MJ 11-A

FIELD SERVICE TECHNICAL MANUAL				Option or Designator
	12 Bit <input type="checkbox"/>	16 Bit <input checked="" type="checkbox"/>	18 Bit <input type="checkbox"/>	36 Bit <input type="checkbox"/>	MJ11 MEMORY

MJ11
MEMORY TIMING AND CONTROL
FCO Cross Reference

MM115 REWORK SHEET

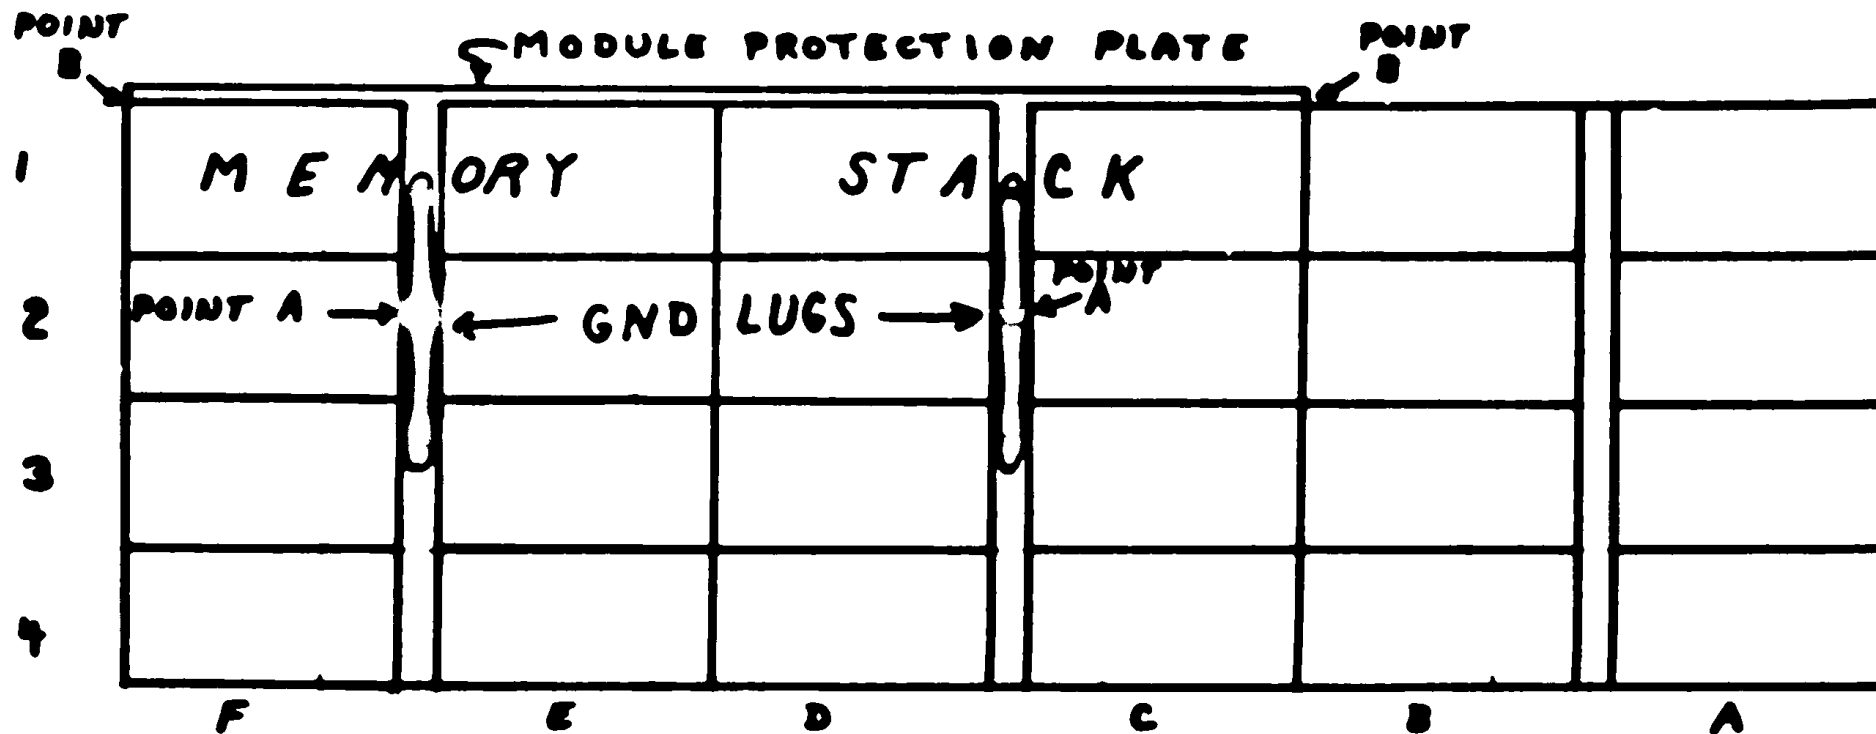
1. LOOSEN 2 SCREWS AT POINTS A. CARE SHOULD BE USED AT ALL TIME SO THAT NO WIRES ARE DAMAGED.
2. SLIDE THE FINGERS OF THE MODULE PROTECTION PLATE UNDER THE GND LUGS. THE PROTECTION PLATE SHOULD BE RIGHT AGAINST THE WIRED ASSY. FRAME, POINT B.
3. TIGHTEN SCREWS.
